Town of Carolina Beach  
 Planning/Inspections Department  
 1121 N. Lake Park Boulevard  
 Carolina Beach, NC 28428  
 Tel (910)458-2978 or Fax (910)458-2997

### FENCE APPLICATION

Project Location DRY DOCK MOTEL - 300 LAKE PARK BLVD SOUTH

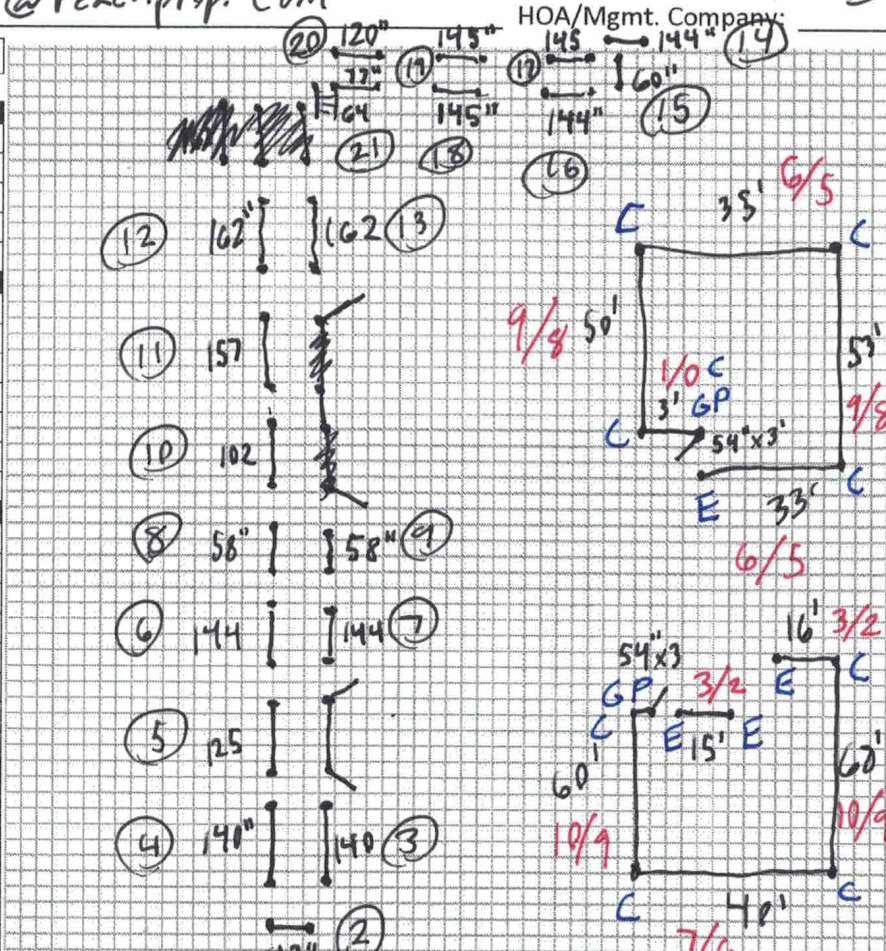
The height of the fence around the pool can only be 4 ft, not 54", because the pool is located within the front setback of the property. Therefore, I need new plans which show the pool fencing will only be 4 ft.

Additionally, the Gator Strong Services document seems to show 2 pools getting new fencing. If this is the case, then you will need to get a second fence permit for the other Dry Dock Motel pool that is addressed to 201 Fayetteville. Since these pools are technically on 2 separate parcels, we need two permits.
